MUNA – Verdi Club Issues with 480 Potrero Development Plan

- 4-2-2013 480 Potrero Project Plan: Six Story, 58 ft, UMU, 77 residential units, (29-18d, 40-28d, 8-38d), 974 ft Retail space, 46 parking, 31 bike parking

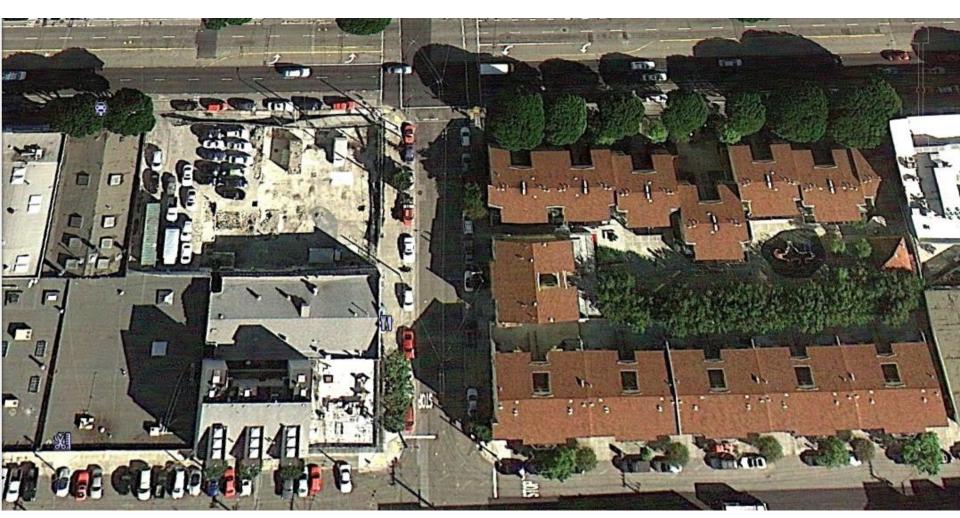
Directly across from 480 Potrero are 3 story residential buildings. The character of this neighborhood enclave would be changed radically with the addition of a 6 story building.

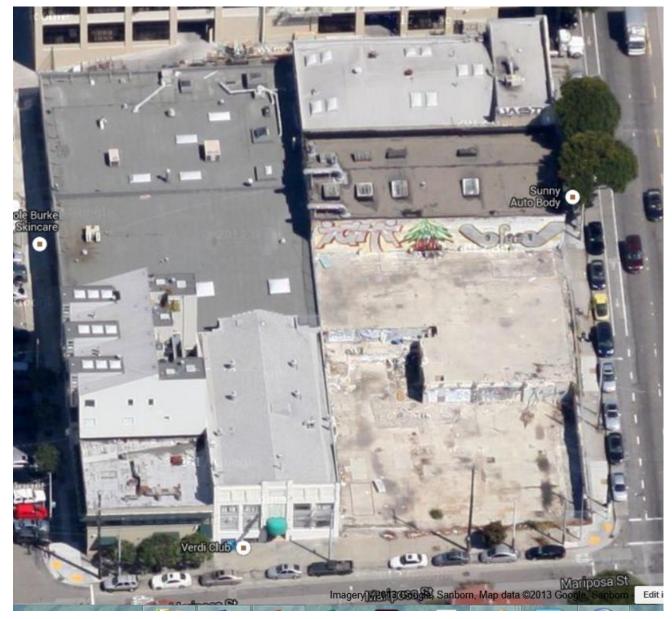
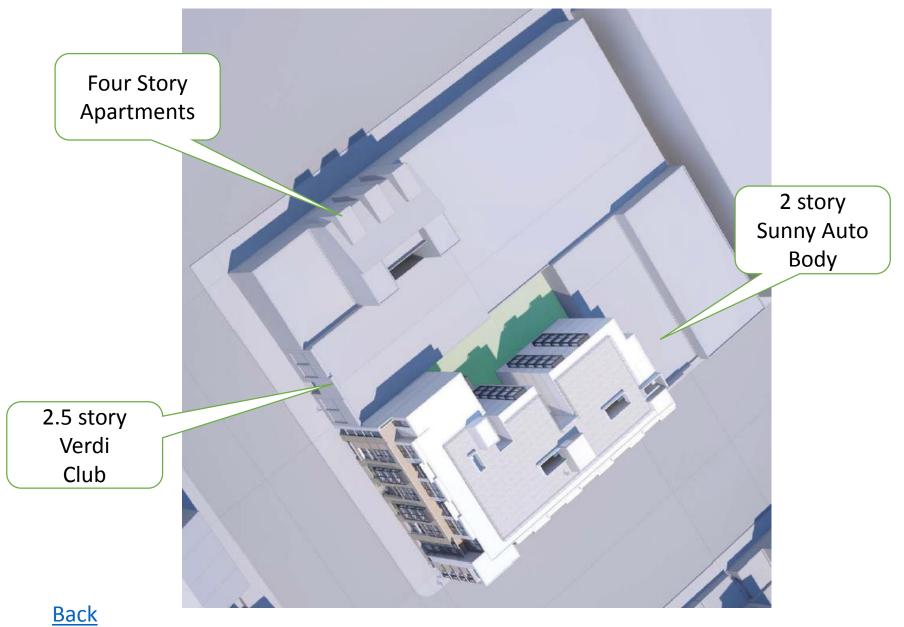
Verdi Club is 2.5 stories. Sunny Auto body is 2 stories. 6 stories plus an additional elevator shaft, stair wells, fencing for "open space" is out of the neighborhood

The height of the proposed building is substantially taller than it's neighbors.

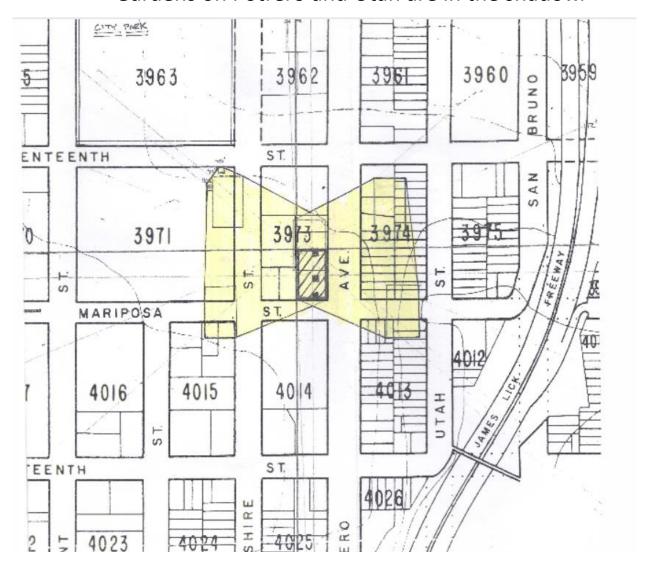
6 stories is significantly higher than the surrounding buildings and will cast a significant shadow on the gardens of homes on the east side of Potrero.

Shadow Analysis from SF Planning shows gardens in shade.

Gardens on Potrero and Utah are in the shadow.

P4 Motion No. XXXXX Case 2011.0430X

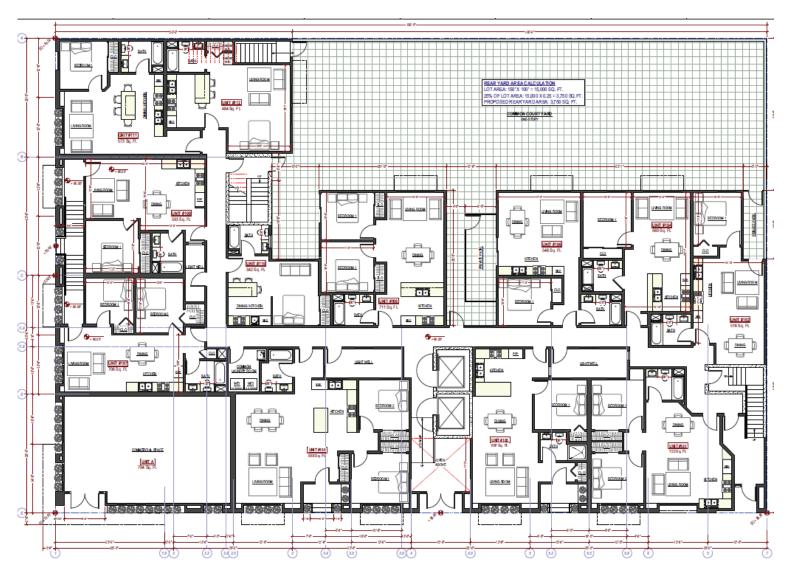
There is no way that the public can access this open space so it must be considered private. In order to reach 6160, SIA included the roof which is not quality usable open space.

The Project does not comply with the rear yard requirement as it does not provide a contiguous 25 percent depth for the full width of lot and is seeking an exception as part of the Large Project Authorization (See discussion under Finding No. 8).

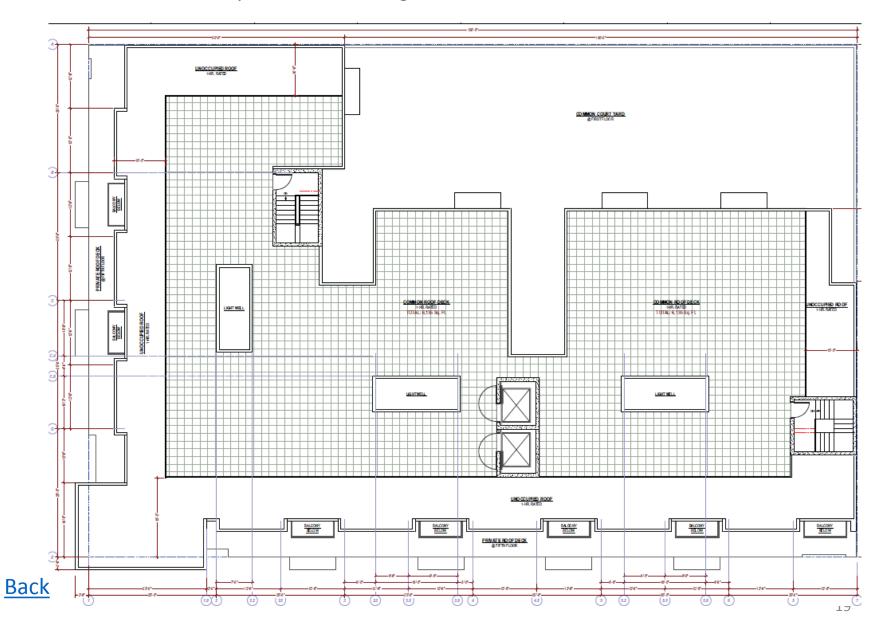
Open Space is on the first floor, above the garage. This is not a place for gardens or trees. The large rectangle is 100x32=3200 feet and less than the required 3750 feet. In order to get to 3750 SIA has added small rectangles which include private balconies

Additional open space is on the roof. This will require at least 3 feet of fencing above the 58 foot planned roof height.
